Taraneh Moayed
150 Tait Avenue
Los Gatos, CA 95030

Date: March 19, 2026

To: Los Gatos Historic Preservation Committee

Re: **Exterior** Modifications to 150 Tait Avenue

VIII. Proposed Siding

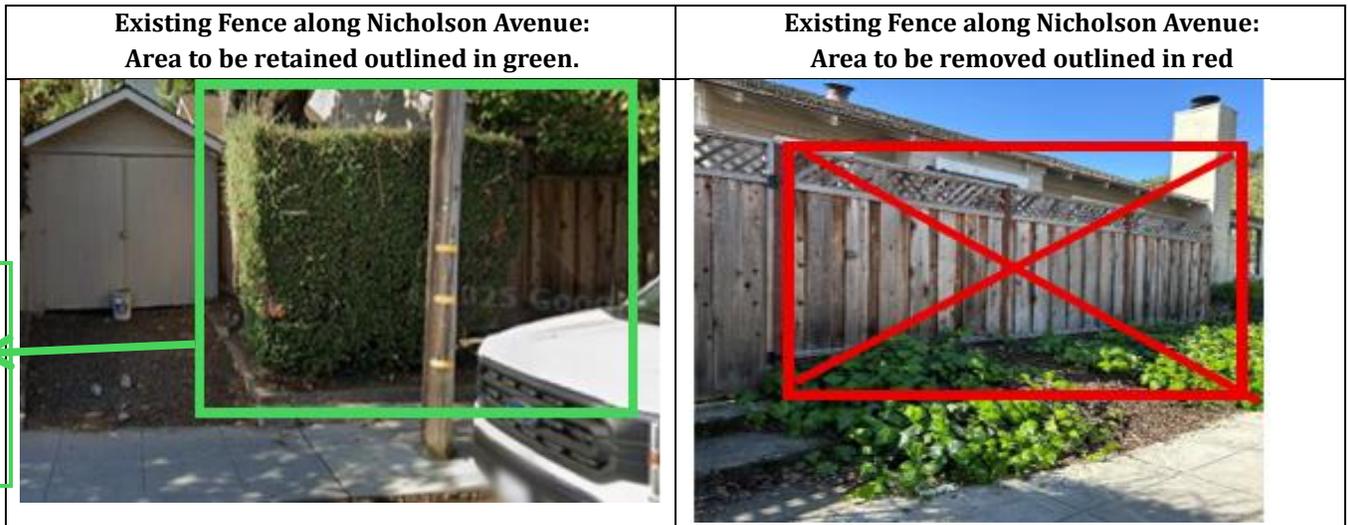
1. **Porch:** The proposed stone gives the design a more modern appearance. If stone is used, the Committee recommends using Los Gatos river rock to ensure compatibility with the neighborhood character;
2. **Corbels:** Retain existing corbels, but reduce the overall number;
3. **Windows:** Match the window trim dimensions to the existing window trim; and
4. **Siding:** Match the siding dimensions of the main house to the existing garage siding, if feasible; and

4. **Siding:** The committee acknowledged that the deteriorated horizontal wood siding of the home is not original to the structure. The Committee suggested matching the replacement siding to the style of the siding of the garage. However, I respectfully request replacing the siding with smooth fiber-cement Hardie board horizontal lap siding installed to match the existing siding's exposure, reveal and profile. Though not original to the home, the existing siding offers a classic and charming look that fully aligns with the style of 1920s cottages. Further, the proposed siding offers durability, weather protection, and fire safety.

The existing siding will be removed and replaced with smooth fiber-cement horizontal lap siding, installed to match the existing shadow lines, scale, exposure, reveal (approximately 4-3/4"), and profile of the existing wood siding. Installation will also include a continuous weather-resistant barrier over exterior sheathing.

C. Installation Method: Horizontal siding with smooth fiber-cement horizontal lap siding installed to match the existing exposure, reveal (approximately 4-3/4"), and profile of the existing wood siding. Installation will also include a continuous weather-resistant barrier over exterior sheathing.
